Access Compliance Report

Public Rights-of-Way

Intersection ID: 44299	Main Street: PEACH_PLACE_LN	Cross Street: ROCKWOOD_RD	Location: NW
ADA ID: CCAD02F5FCD9	Ramp Type: PerpDiag	Initial Pass/Fail: Fail	Overall Compliance: No
Severity Score: 10			
Codes/Mitigation Info/Possible Solution		Field Measurements/Component Compliance

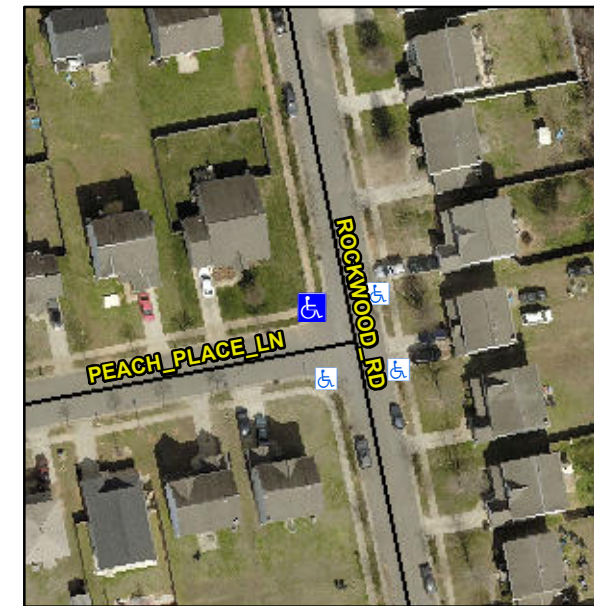
Not Found, R304.5.1, R304.5.3

Compliance	Description	Data	Compliance	Description	Data
N/A	Ramp Length (in)	49.5	Yes	Ramp Slope (%)	7.2
No	Ramp Width (in)	37.5	No	Ramp XSlope (%)	4.1
N/A	Flare Type LT	N/A	N/A	Flare Type RT	N/A
N/A	Flare Slope LT (%)	N/A	N/A	Flare Slope RT (%)	N/A
N/A	Flare Traversable LT?	N/A	N/A	Flare Traversable RT?	N/A
N/A	Landing Length (in)	N/A	N/A	DWS Provided?	N/A
N/A	Landing Width (in)	N/A	N/A	DWS Contrast?	N/A
N/A	Landing Slope (%)	N/A	N/A	DWS Length (in)	N/A
N/A	Landing X Slope (%)	N/A	N/A	DWS Full Width?	N/A
N/A	Landing Curb? (Y/N)	N/A	N/A	DWS Offset (in)	N/A
N/A	Shared Landing?	N/A			
N/A	Gutter Ponding?	N/A	N/A	Gutter Slope (%)	N/A
N/A	Gutter Lip Ht (in)	N/A	N/A	Gutter X Slope (%)	N/A
N/A	Painted X Walk1?	No	N/A	Painted X Walk2?	No
	X Walk 1 Direction	To S		X Walk 2 Direction	To E
N/A	X Walk 1 Width (in)	N/A	N/A	X Walk 2 Width (in)	N/A
	X Walk 1 Slope (%)	3.2		X Walk 2 Slope (%)	1.6
	X Walk 1 X Slope (%)	1.5		X Walk 2 X Slope (%)	3.8

Remove & Replace Curb Ramp With Two New Directional Ramps or Equivalent.
